## Schedule B-3 - Purchaser's Extras

**BELLAIRE PROPERTIES INC.**

LOT NUMBER: 95 PHASE: 5 MODEL: FRASER 2250 ELEVATION A

SECOND FLOOR ELEVATION B

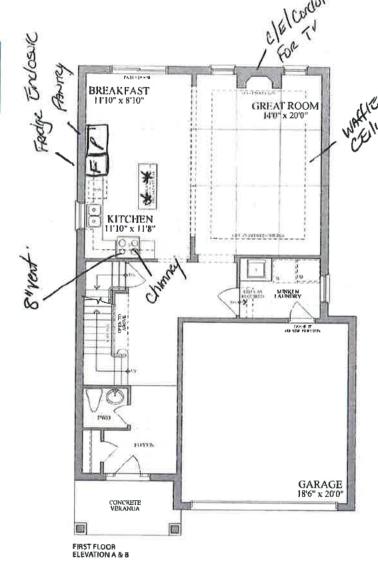
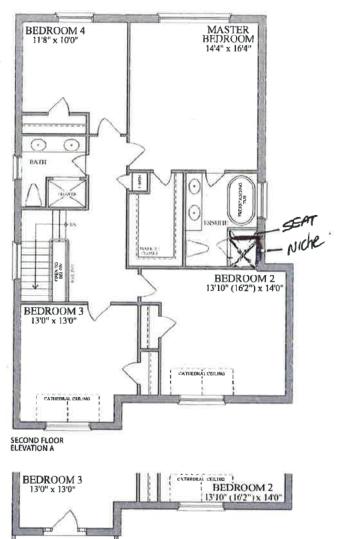
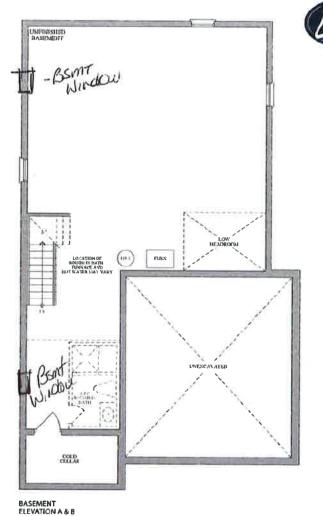
15.	SHOWER NICHE - Cost to provide 1 shower niche in shower enclsoure (if applicable) per bathroom. Price is based on standard wall tile and standard marble jamb. Size of niche is approximately 12" x 20" x 3 1/2" deep, see sketch for location
